Proposed Turkey Point Units 6 and 7  
Docket Nos. 52-040 and 52-041  
FPL Revised Response to NRC RAI No. 02.05.02-3 (eRAI 5896)  
L-2013-305 Attachment 2 Enclosure A Page 1 of 3

**NRC RAI Letter No. PTN-RAI-LTR-037**

**SRP Section: 02.05.02 - Vibratory Ground Motion**

**NRC RAI Number: 02.05.02-4 (eRAI 5896)**

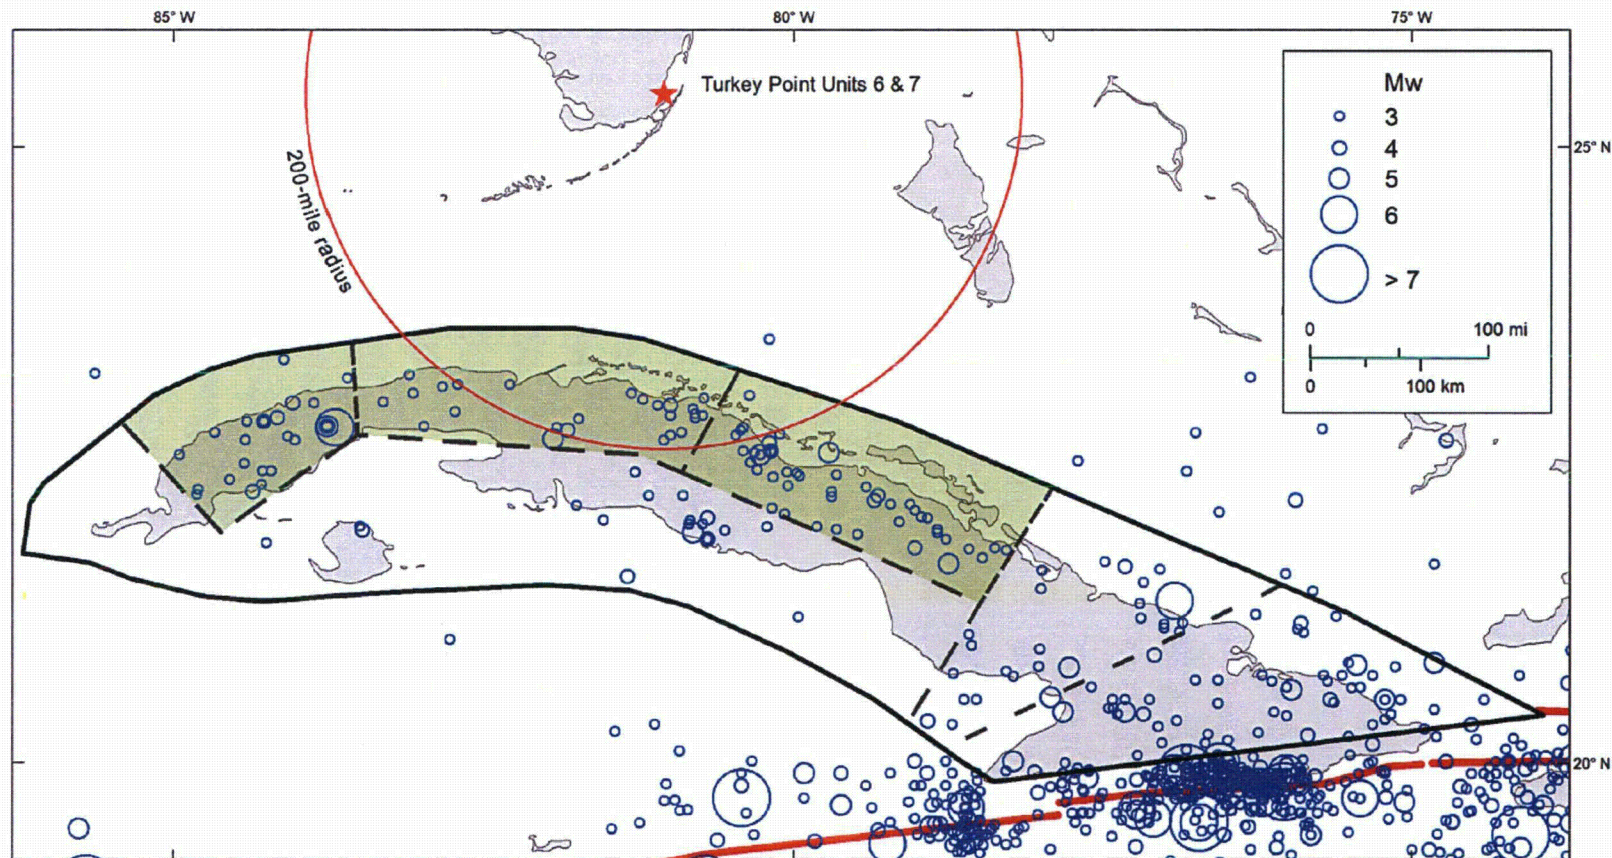
- a. Rationale for the exclusive use of an areal source rather than multiple areal sources or a combination of fault sources and areal sources. Given the uncertainties, does the use of a single areal source result in a more conservative representation of the hazard from the Cuba seismic sources?

- c. A description of how well the seismic source model parameters represent the observed spatial patterns and concentrations of seismicity. Is a uniform seismic source zone justified considering FSAR Figure 2.5.1-267, which shows prominent clusters of seismicity? Discuss evidence, if any, that frequency-magnitude behavior is different for the subset of earthquakes concentrated in western and northern Cuba than for the entire zone.

- Six areal source zones scenario (Z6): In the six areal source zones scenario, Cuba is divided into six zones largely on the basis of observed patterns in seismicity (Figure 1). The seismicity *b*-value is constant across all six zones and equivalent to that used in the Z1 scenario; the seismicity *a*-values vary from zone to zone, are uniform within each zone, and are based on the observed seismicity within each zone. The Z6 scenario results in the lowest contribution to hazard from the three zone scenarios (Table 1).

The influence of variations in seismicity rate within the single areal zone (Z1) are investigated through hazard sensitivity calculations in two scenarios: (1) the Z11% scenario, in which the rate for the entire single areal source zone is increased by 11%, corresponding to the average rate within a small portion of that zone nearest the site (i.e., the "northern Cuba subzone") (Figure 1); and (2) the Z6 scenario, in which the single areal zone is divided into six subzones defined by variations in seismicity patterns and rates (Figure 1). Part (c) of this response includes additional details on recurrence parameters for the Z11% scenario. The Z11% scenario provides a conservative representation of the effect of potentially diluting the effects of apparent higher seismicity rates in northern Cuba through use of a single large areal zone that includes areas of relatively lower seismicity activity rate.

For the six-zone scenario (Z6), each of the six zones is given equally weighted maximum moment magnitudes of 7.0 and 7.3 with uniformly distributed seismicity parameters (complete smoothing) determined from the earthquakes within each zone. The completeness table for Cuba from Garcia et al. (2008) (FSAR 2.5.2 Reference 255) is also used here. The a-values were determined by counting the number of events in each

Figure 1. Comparison of converted magnitudes for the complete modified Phase 2 catalog: FSAR vs. CEUS SSC (EPRI et al., 2012). This figure represents the  $M_w$  correlation among 10,747 events.

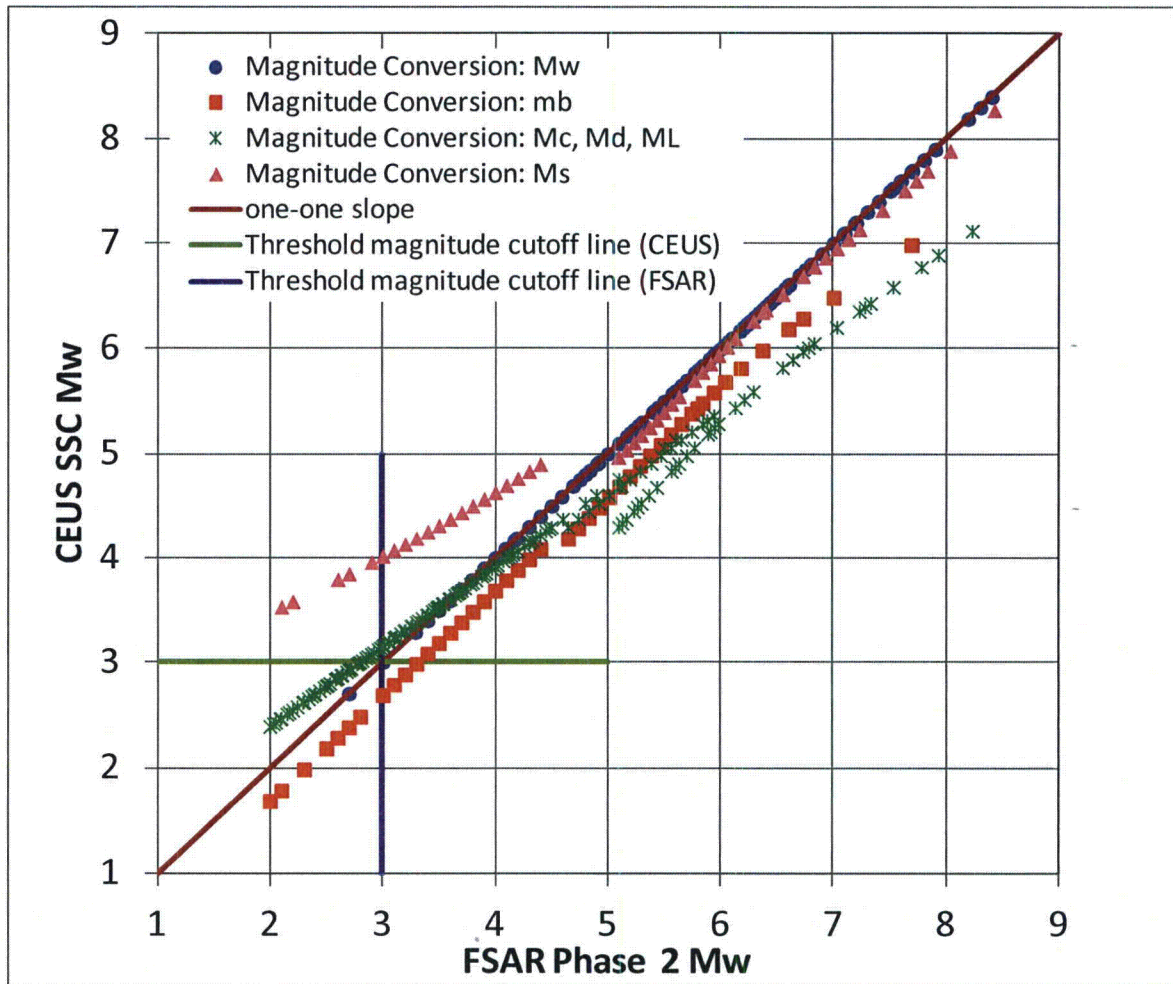
FSAR Subsection 2.5.2.1.3.1 states that  $M_w$  was used as the uniform magnitude measure in Phase II (Caribbean region) earthquake catalog development efforts. Phase I earthquake catalog (EPRI updates), on the other hand, uses  $m_b$  as the uniform magnitude measure. In accordance with NUREG-0800, Standard Review Plan, Chapter 2.5.2, "Vibratory Ground Motion," and Regulatory Guide (RG) 1.208, "A Performance-Based Approach to Define the Site-Specific Earthquake Ground Motion", please explain the rationale for selecting  $M_w$  as the uniform magnitude measure for the Caribbean earthquake catalog rather than  $m_b$ . Discuss what impact, if any, this choice had on the number of earthquakes listed in the Caribbean earthquake catalog. Were there any earthquakes with  $m_b$  of 3.0 (or perhaps larger) that did not make the  $M_w \geq 3.0$  cut used in Phase II catalog development?

leads to a smaller estimate of moment magnitude than considered in the FSAR – see Figure 1. For example, if the CEUS-SSC magnitude conversion relations had been considered for the Phase 2 catalog, the moment magnitude equivalent to  $m_b$  3.0 would be about  $M_w$  2.7, instead of the  $M_w$  3.0 in the FSAR.

Figure 1 indicates that for about M<sub>w</sub> 3.5 and greater, the CEUS SSC leads to smaller converted M<sub>w</sub> magnitudes, notably so for the largest magnitudes. For M<sub>w</sub> less than about 3.5 the CEUS SSC magnitude conversions lead to slightly larger M<sub>w</sub> magnitudes. Further, considering the intent of presenting the Phase 2 catalog as M<sub>w</sub> 3.0 and greater, the CEUS SSC magnitude conversions would add some additional events which the FSAR catalog would have considered M<sub>w</sub> 2.8 to 3.0.

leads to very similar estimates of moment magnitude for earthquakes larger than 4.5 as those that were considered in the FSAR (FSAR 2.5.2) – see Figure 1. For the relatively few events with M<sub>s</sub> less than 4.5 in the Phase 2 catalog, the CEUS SSC magnitude conversion leads to larger M<sub>w</sub> magnitudes than the conversion assumption of equivalence in the FSAR.
